REMARKS

In view of the amendments and remarks herein, favorable reconsideration and allowance of this application are respectfully requested. By this Amendment, claim 34 has been amended to avoid "means" language. Claims 1-8, 31 and 34 are pending for further examination. The remaining claims have been withdrawn from further consideration based on the restriction/election.

With respect to the objection to the drawings, Applicant has filed herewith a proposed drawing correction in which "Prior Art" labels have been added to FIGS. 9-13. Approval of the proposed drawing corrections are respectfully requested.

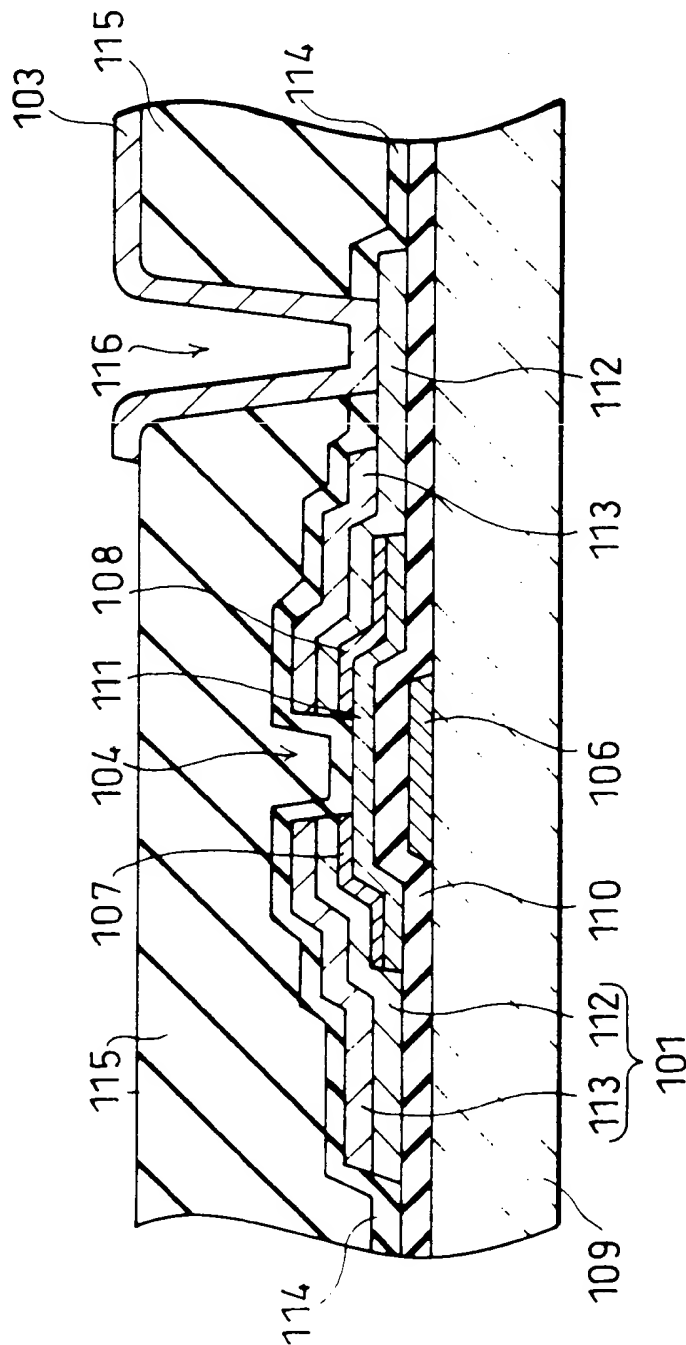
The attached replacement sheets of drawings include changes to Figs. 9-13. The replacement sheets, which includes Figs. 9-13, replaces the original sheets including Figs. 9-13.
